# **HUNTS POINT INTERSTATE ACCESS IMPROVEMENT PROJECT – CONTRACT 3**

**PIN X731.65, Contract D900055**

**Addendum #9**

**July 29, 2022**

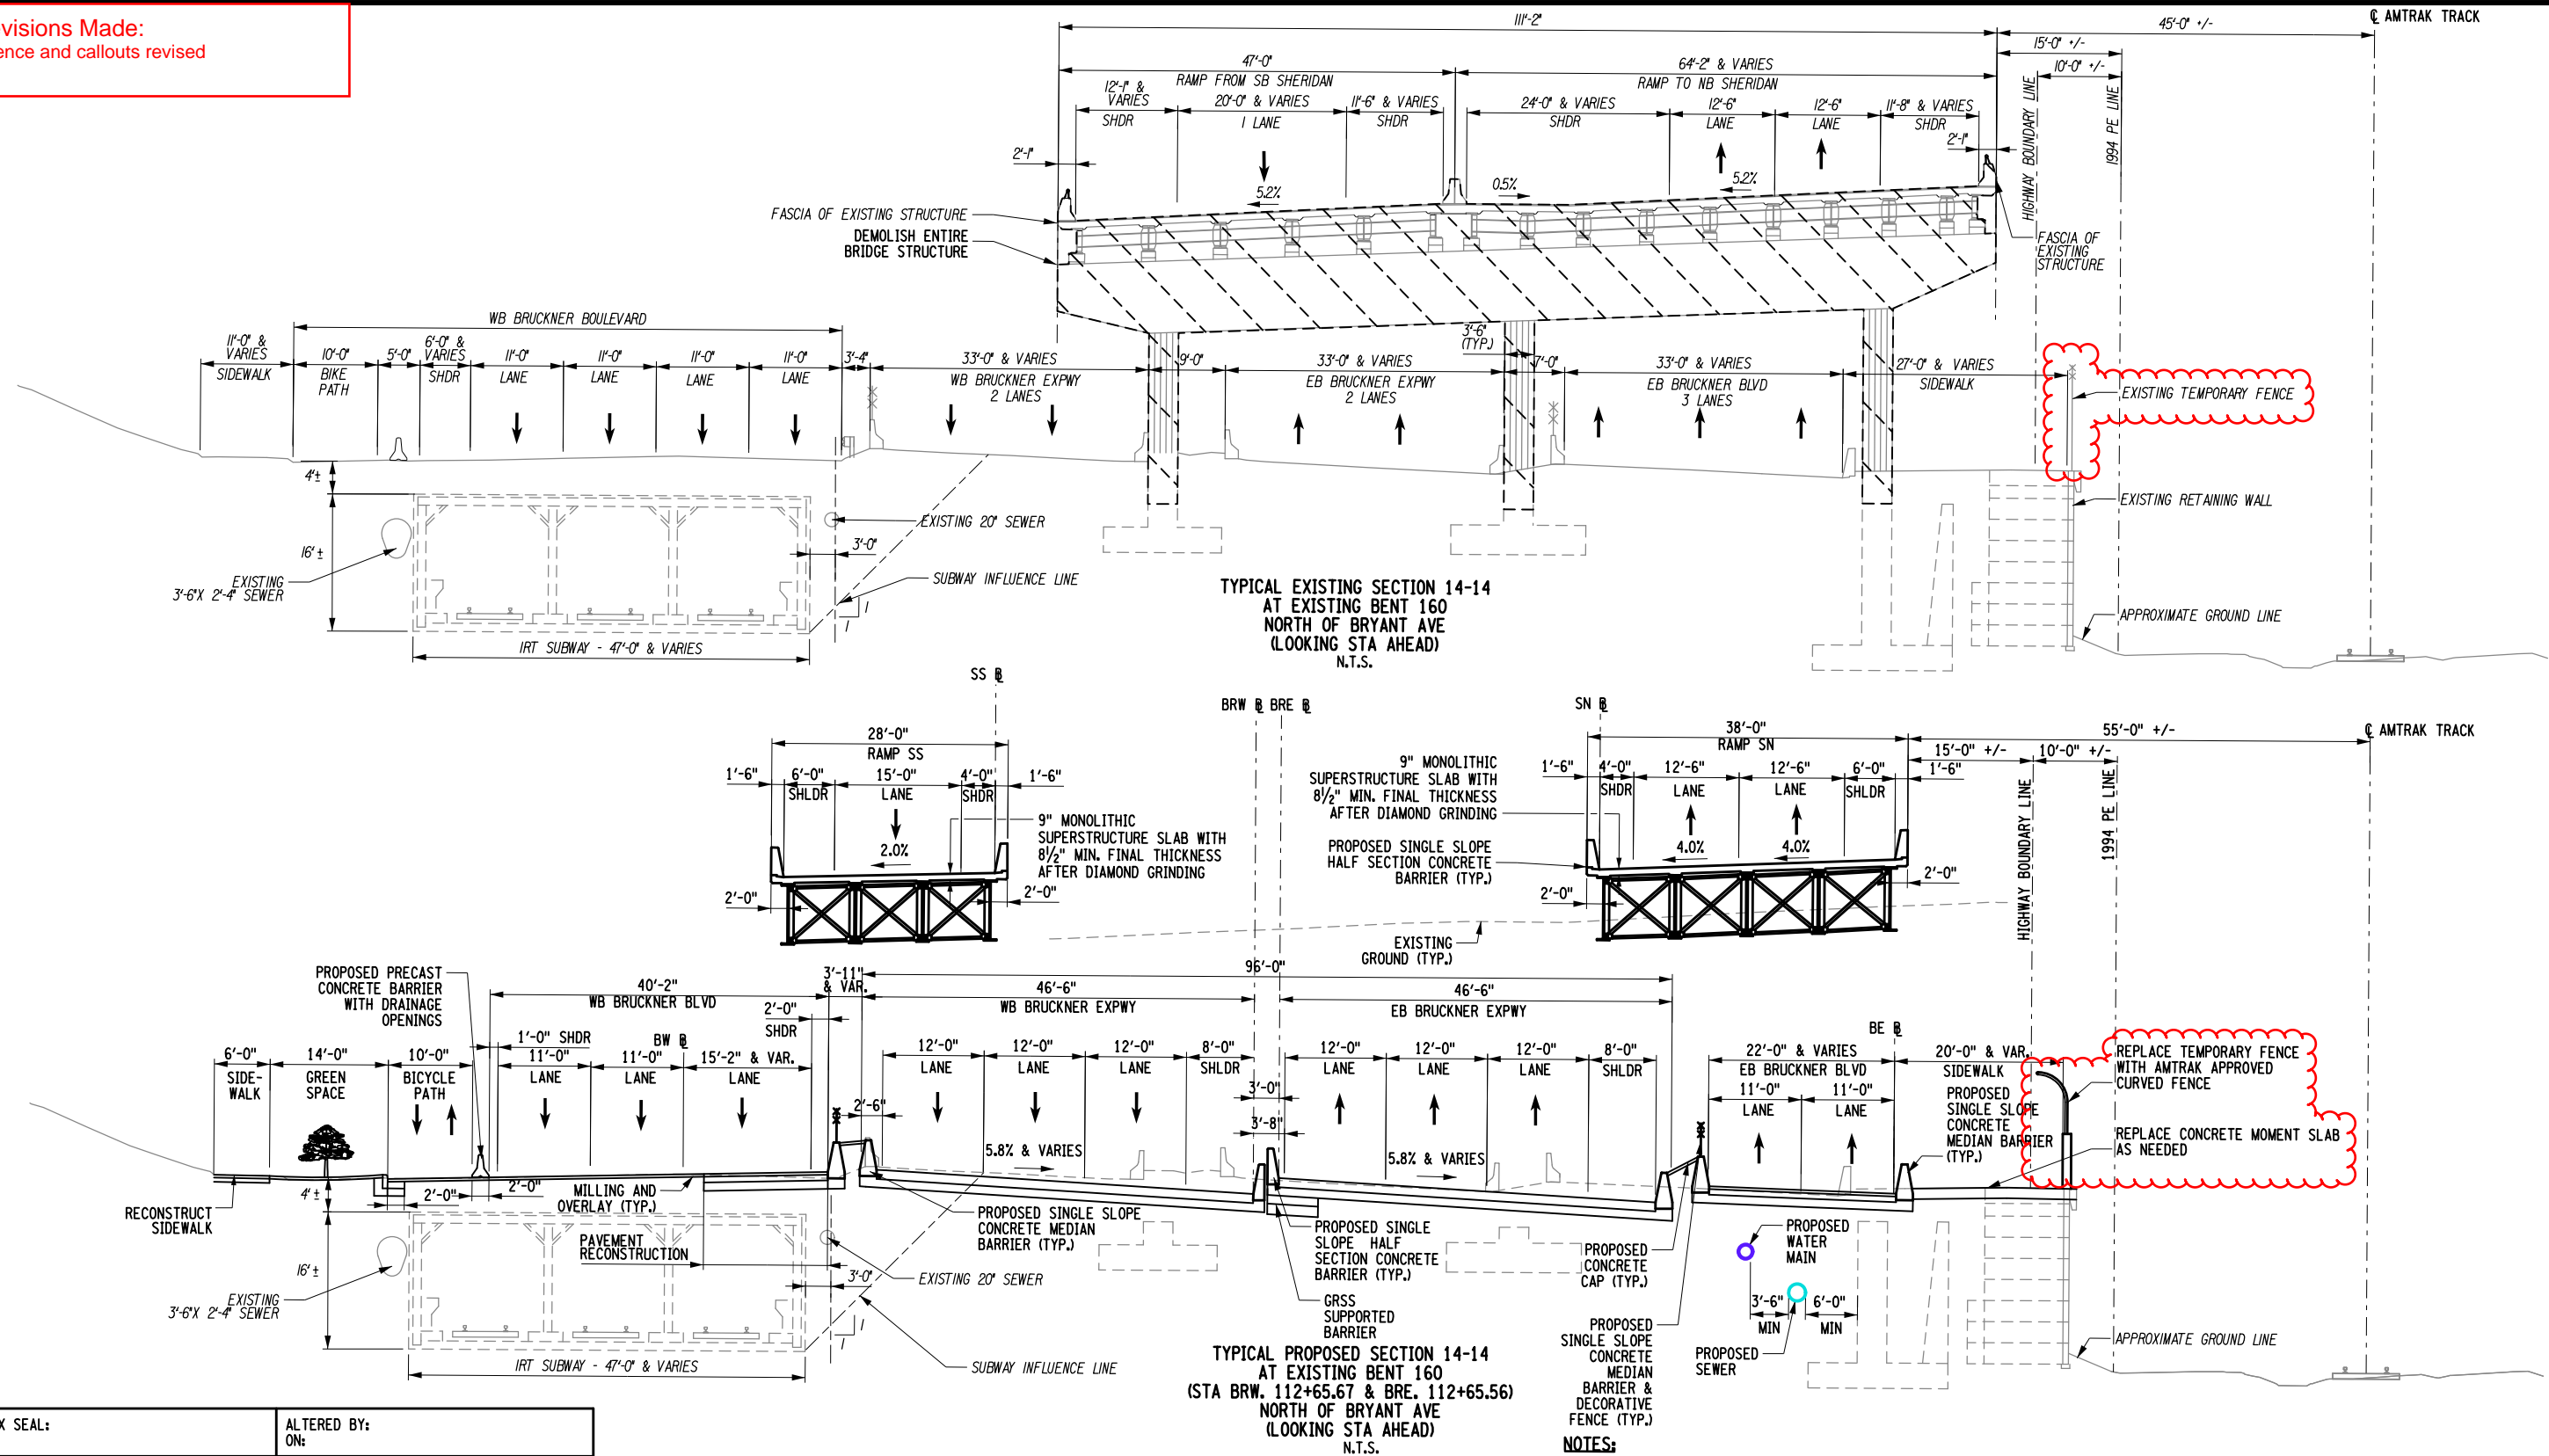
**Revisions Made:**  
- Fence and callouts revised

TYPICAL SECTION  
RAMP SN AT PIER SN-8  
(STA. SN 114+83.08)  
SECTION 15-15  
(LOOKING STA AHEAD)  
NOT TO SCALE

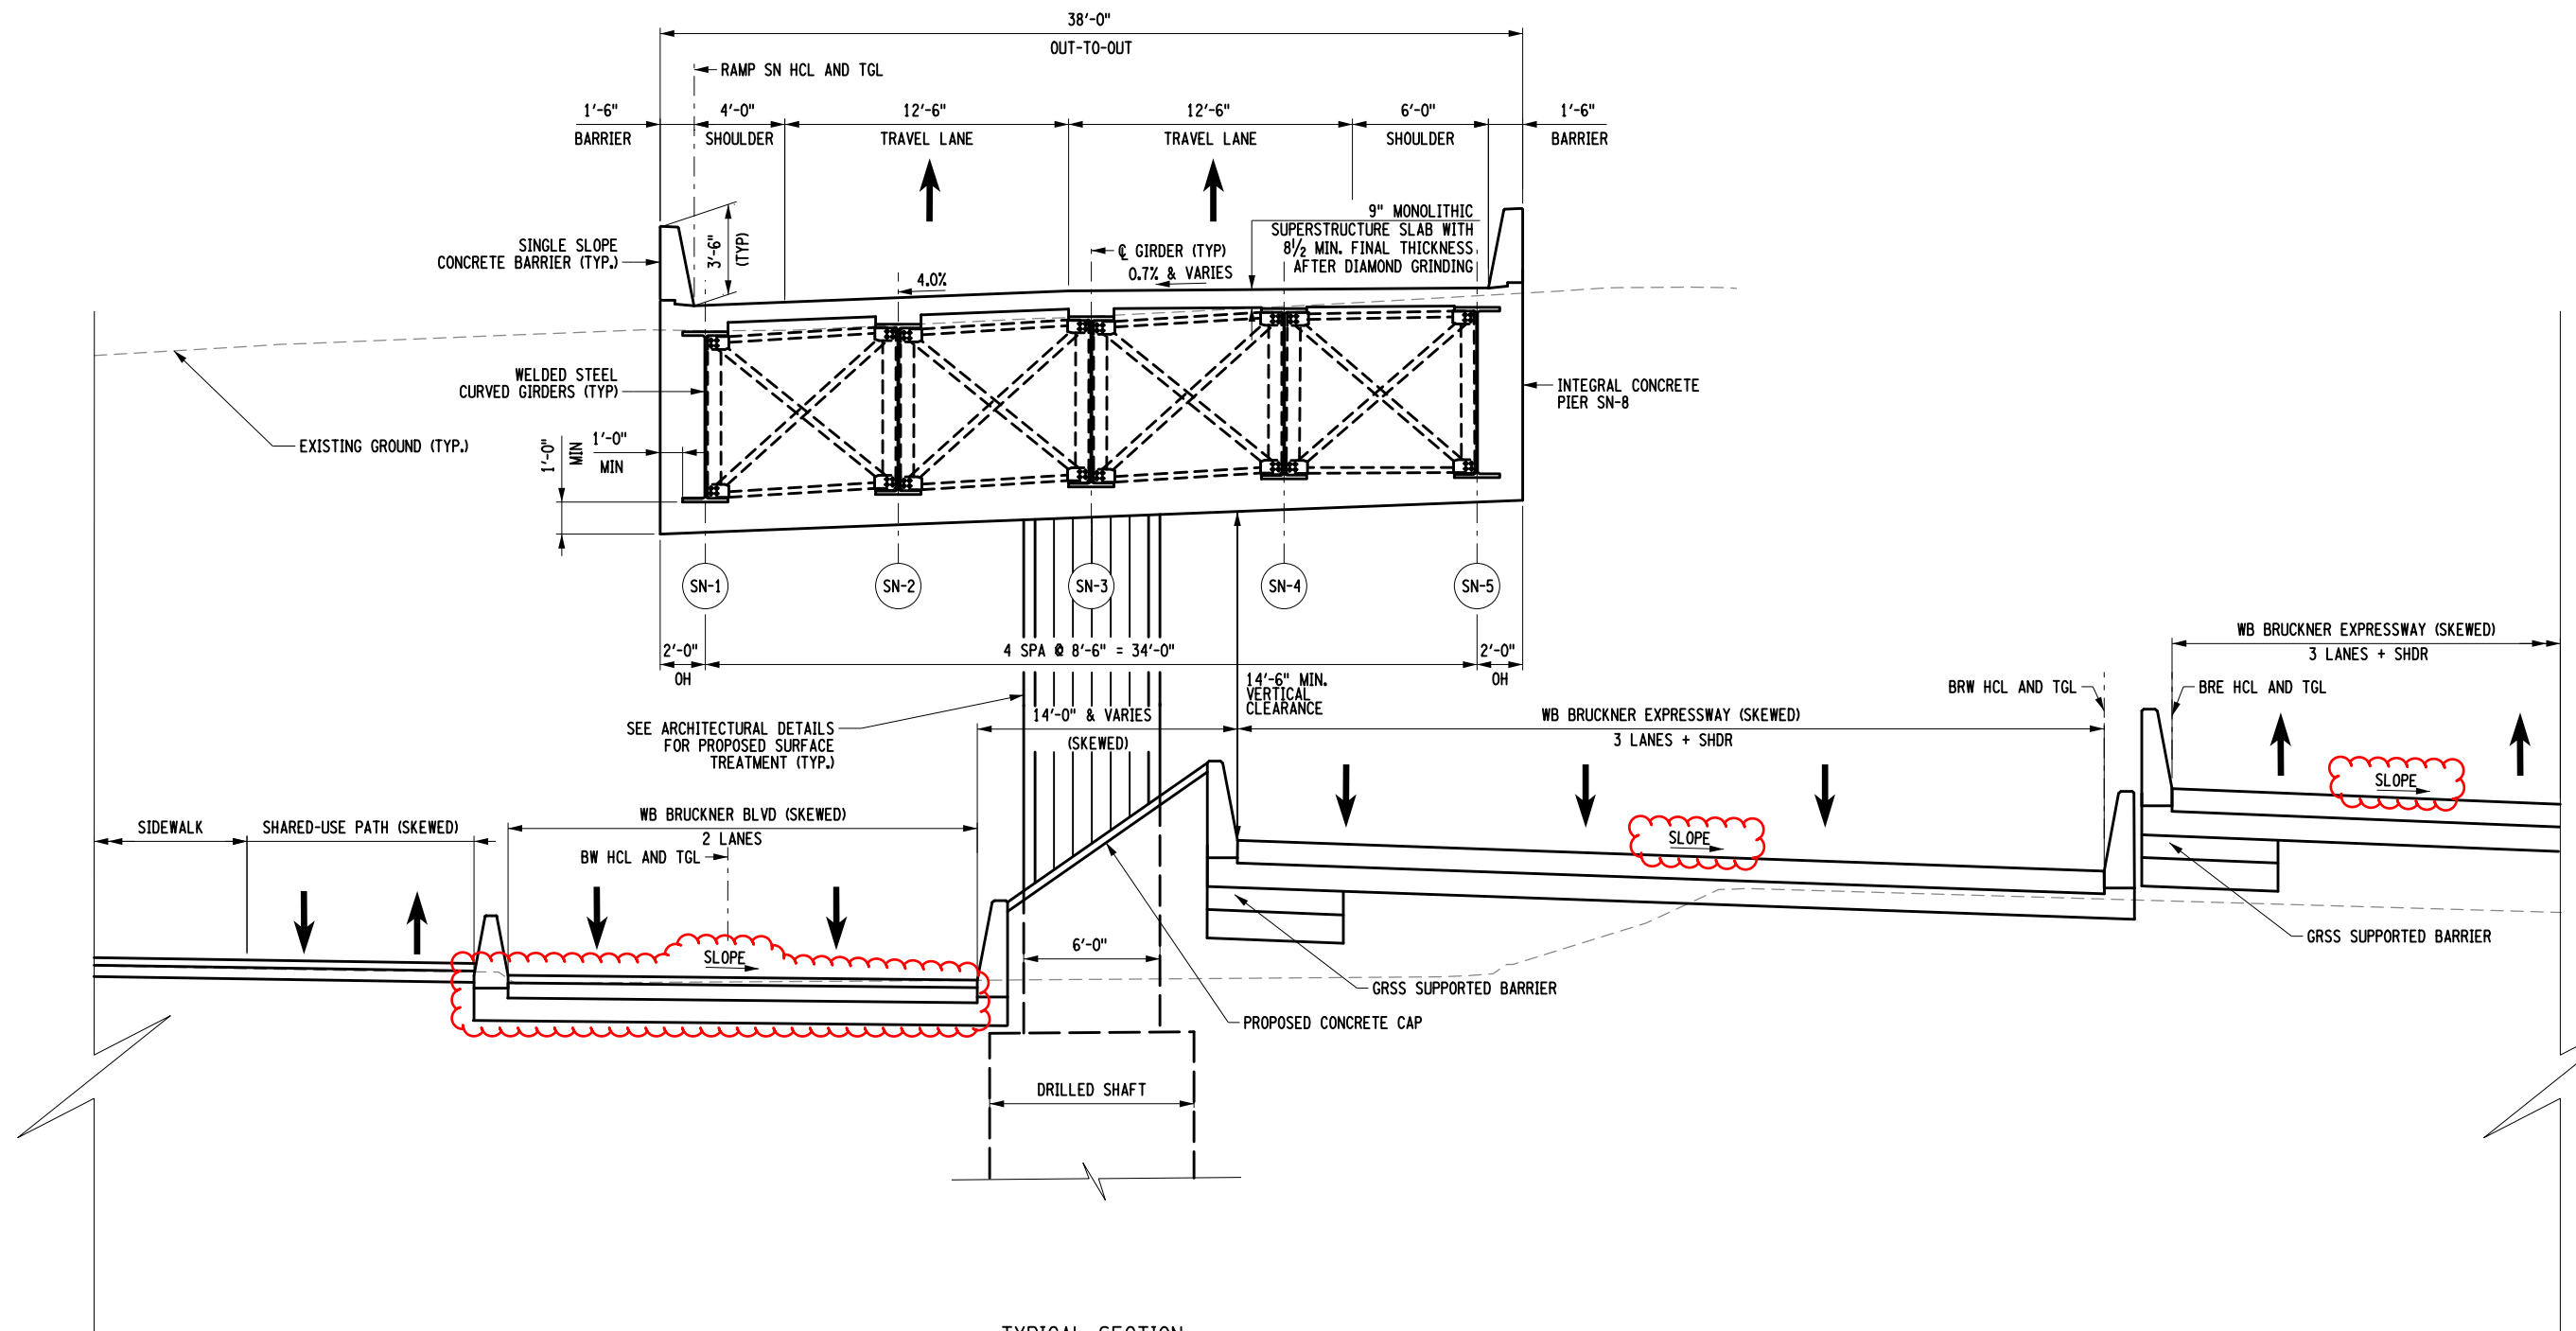
- Cross slope WB Bruckner Blvd revised
- Slope labels added

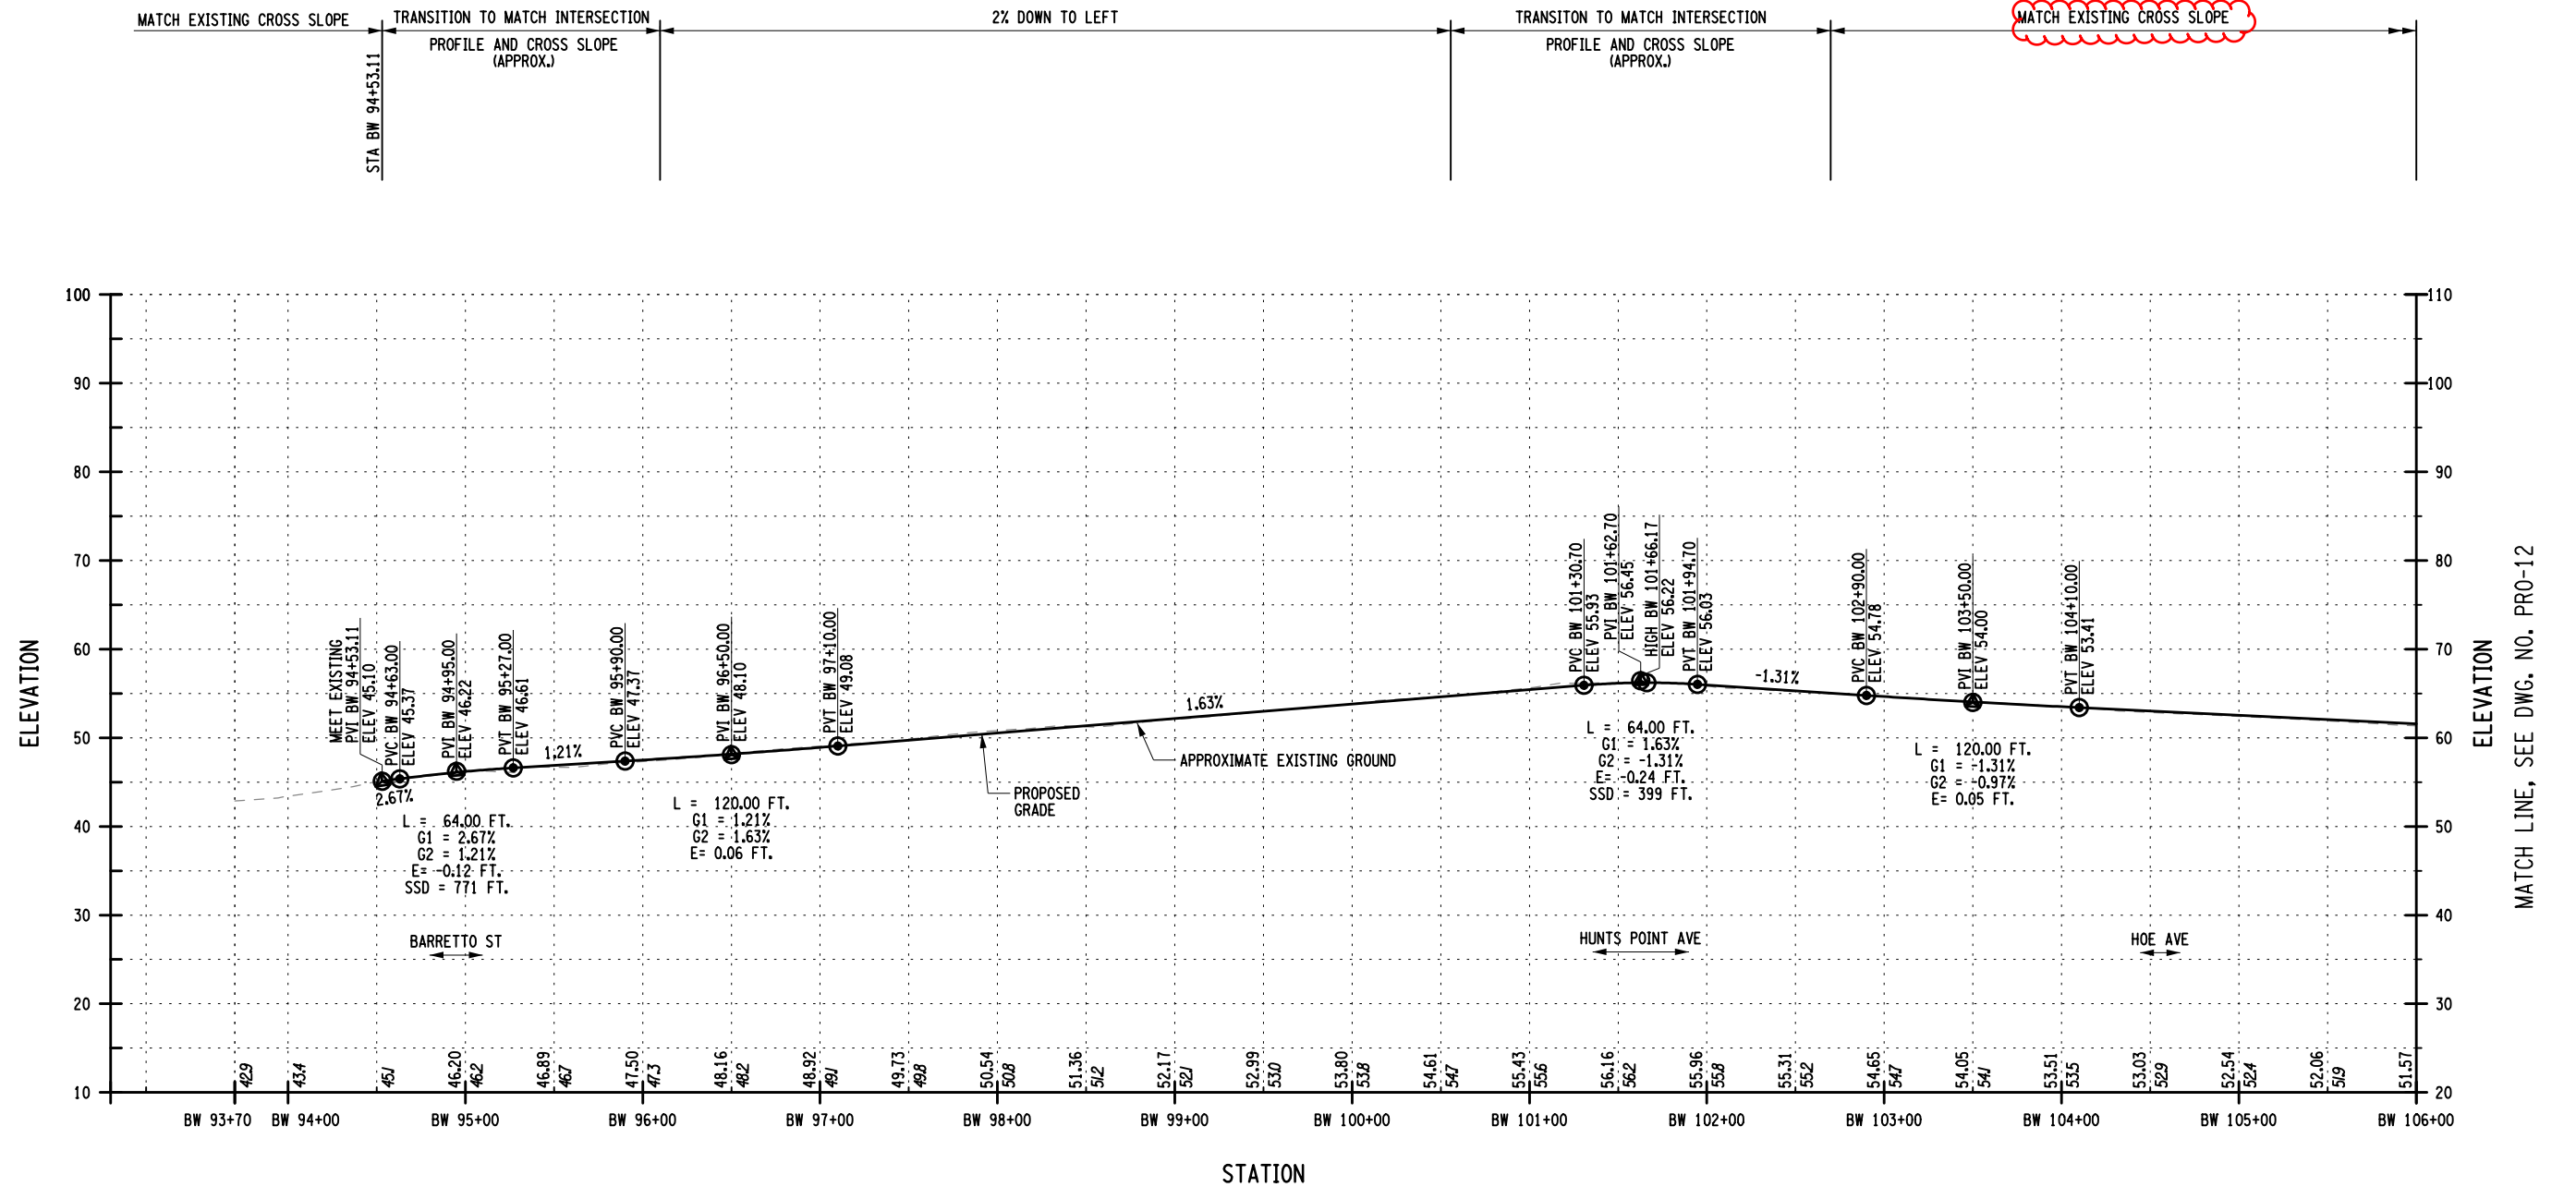
Revisions Made:  
- Cross slope label revised

DRAWING NO. UP-06

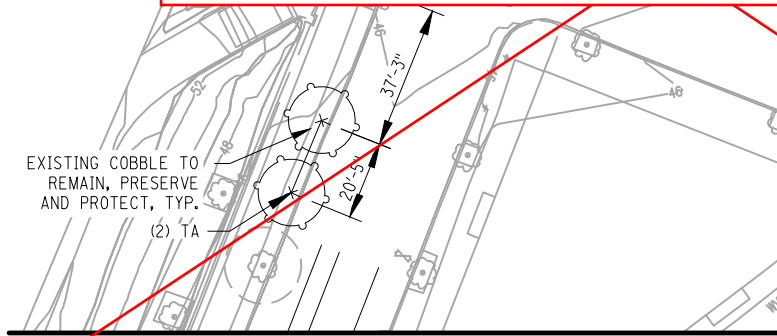
SHEET REMOVED FROM RFP PART 6
